L-2018-223
10 CFR 54.17

Re: Florida Power & Light Company
Turkey Point Units 3 and 4
Docket Nos. 50-250 and 50-251
Turkey Point Units 3 and 4 Subsequent License Renewal Application Safety
Review - November 15, 2018 Public Meeting Action Item Responses

The purpose of this letter is to provide, as attachments to this letter, responses to the discussion topic action items assigned to FPL during the referenced public meeting. These responses revise and supersede (or supplement) the corresponding RAI and On-Site Regulatory Audit Follow-up Item responses in References 4, 5, 6 and 7.

Revise Figures 4.5-7, 8, 9, 10 as follows:

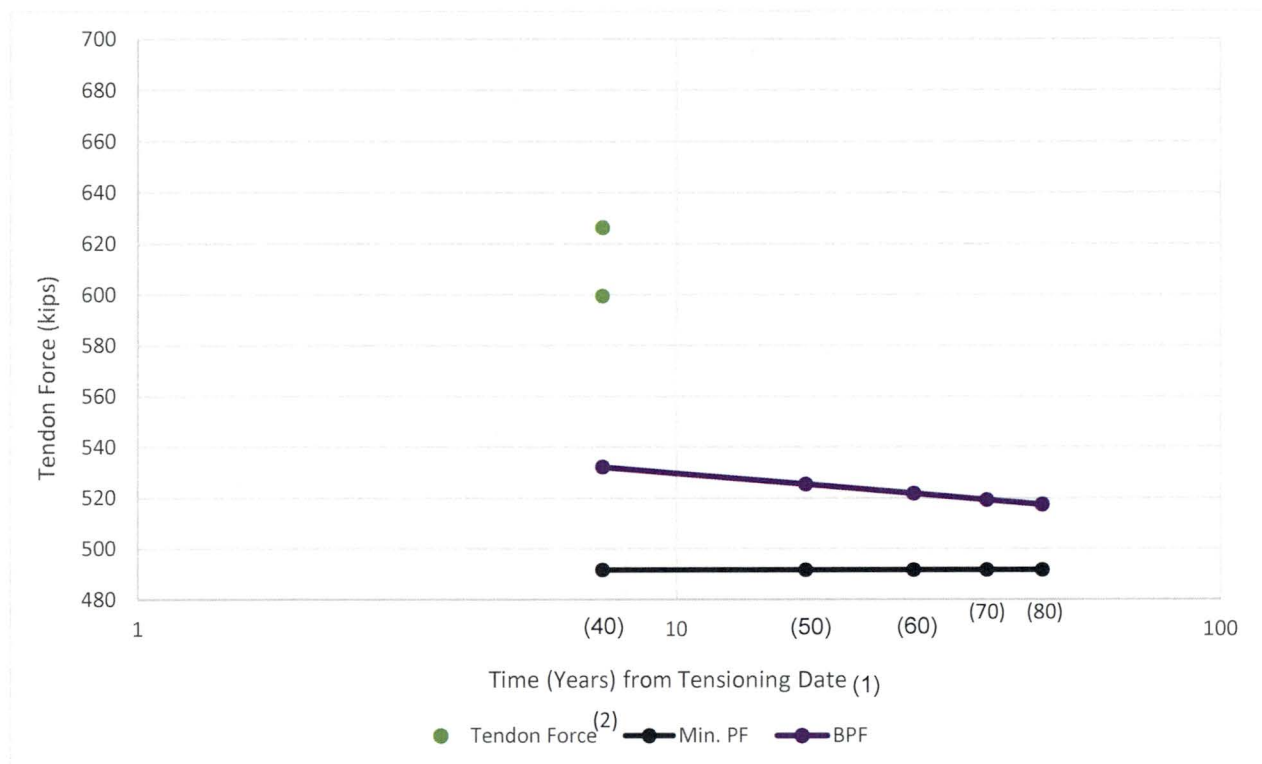
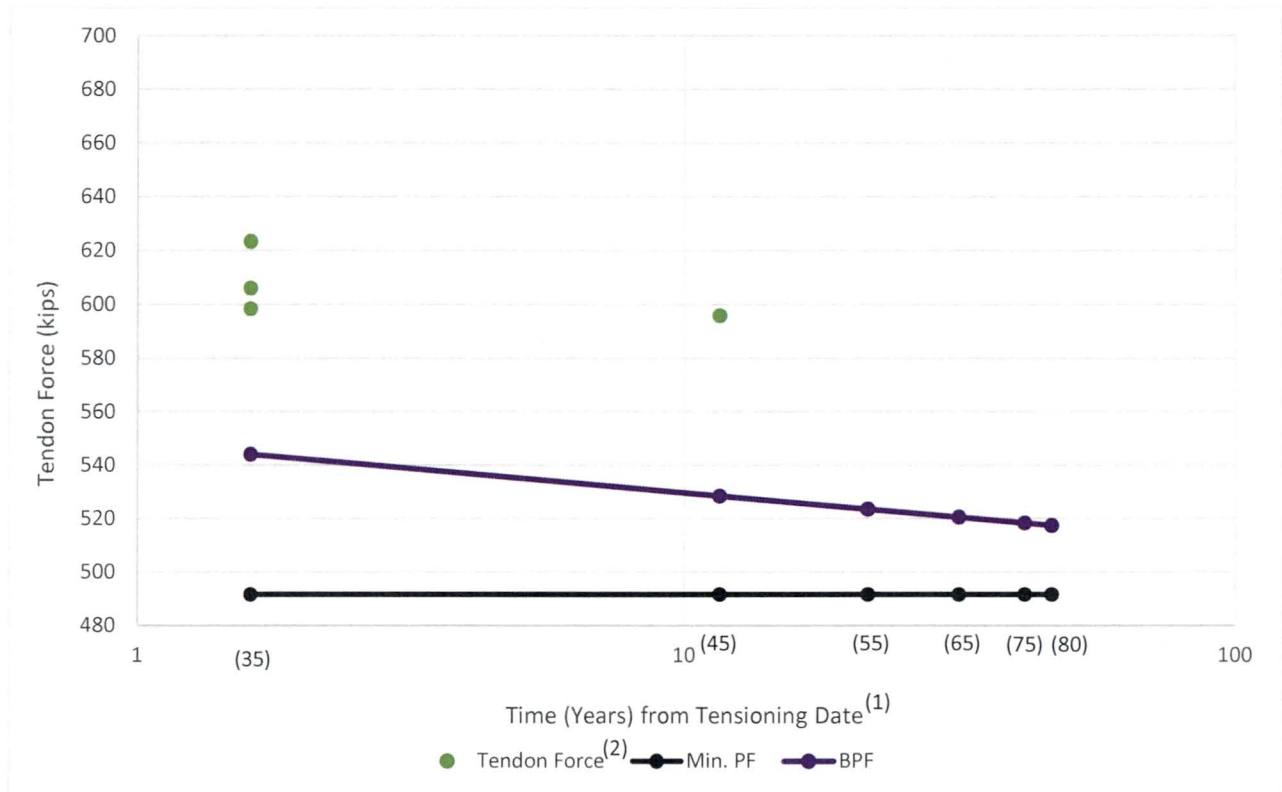
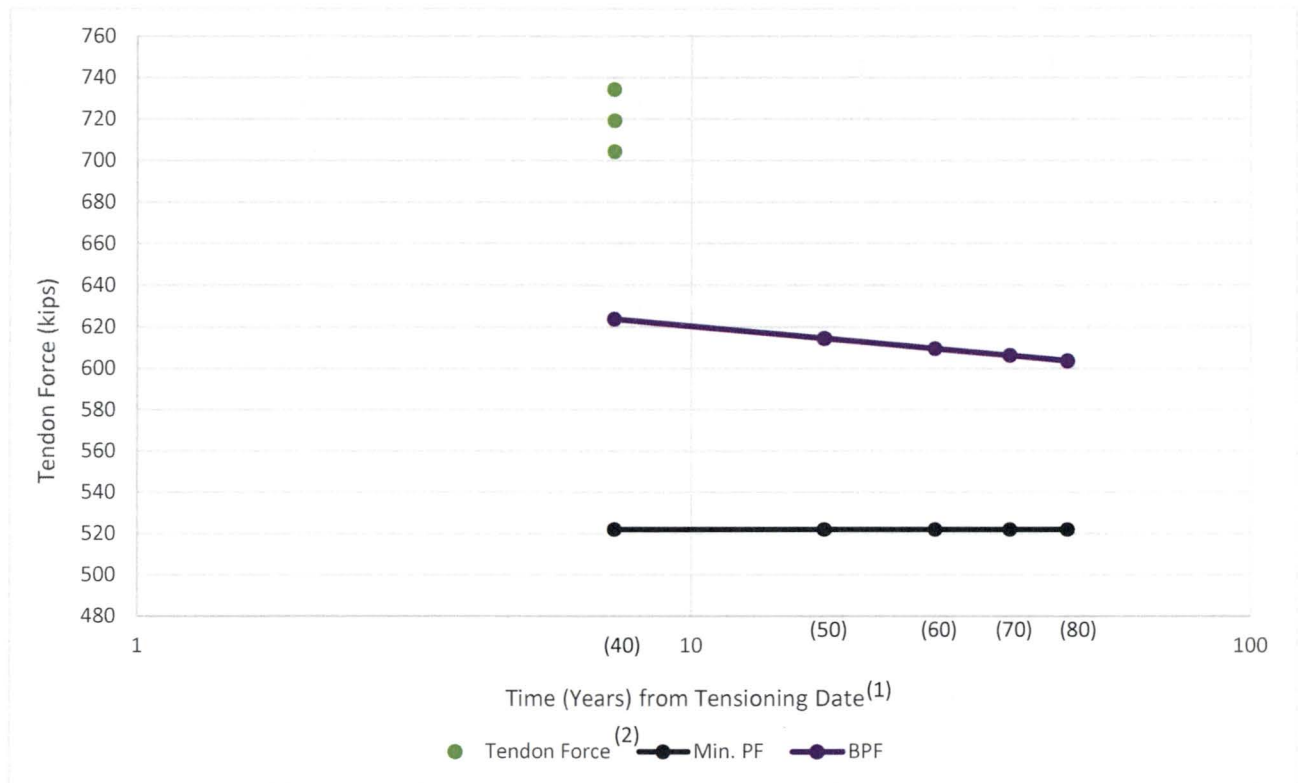
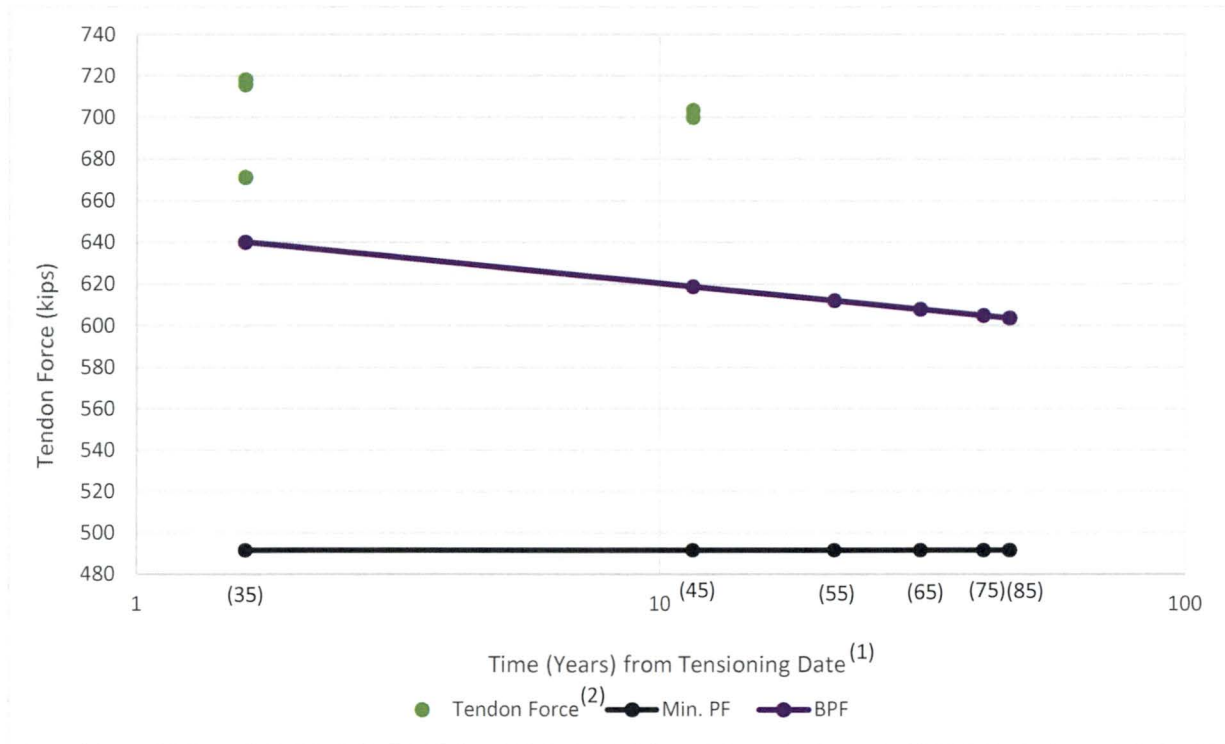
- The Turkey Point Unit 3 and Unit 4 RVCH Replacement Projects required a containment access opening consisting of the removal and later replacement of a section of the containment structures. The Unit 3 and Unit 4 tendons affected by the RVCH modification are considered as augmented scope tendons and are analyzed separately from the Unit 3 and Unit 4 tendons for SLR. The tendon loss of prestress calculation was updated to separate the augmented scope tendons from the original scope tendons which eliminated the considerable tendon lift-off force variation.

- The Unit 3 and Unit 4 tendons affected by the RVCH modification are considered as augmented scope tendons and are analyzed separately from the Unit 3 and Unit 4 tendons for SLR. The containment loss of prestress calculation was updated to separate the augmented scope tendons from the original scope tendons for the regression analysis to remove the false

In Figure 4.5-8, one result is listed for the Unit 4 hoop tendon 45th year (vs. the sample size of two) since one of the RVCH tendons (tendon 15H35) was surveyed as an alternate for the planned inspection RVCH tendon (tendon 15H32) that was determined to be inaccessible. The data for the alternate RVCH tendon (tendon 15H35) was not displayed in the TLAA Figure 4.5-8 since only average lift-off force for the tendon could be reported. The tendon lift-off data analyzed and presented in the TLAA for License Renewal (surveillance years 1-25) and the 30th and 35th years' surveillance reports is presented as normalized lift-off forces. The data in the 40th and 45th years' surveillance reports is presented as average lift-off forces. Instead of applying the Normalization Factor to the as-found lift-off force, the 40th and 45th surveillance report methodology applies the Normalization Factor to the Baseline Predicted Force. The 45th years' tendon selection and predicted forces report is used to convert the average lift-off force data to normalized lift-off force data by back-calculating the Normalization Factor from the Baseline Predicted Force. Since tendon 15H35 was not a planned inspection tendon, the predicted force (PF) and baseline predicted force (BPF) were not calculated in the tendon selection and predicted forces report. Therefore, the Normalization Factor could not be determined. The average lift-off force is greater than the PF and BPF; therefore, the tendon force is acceptable.
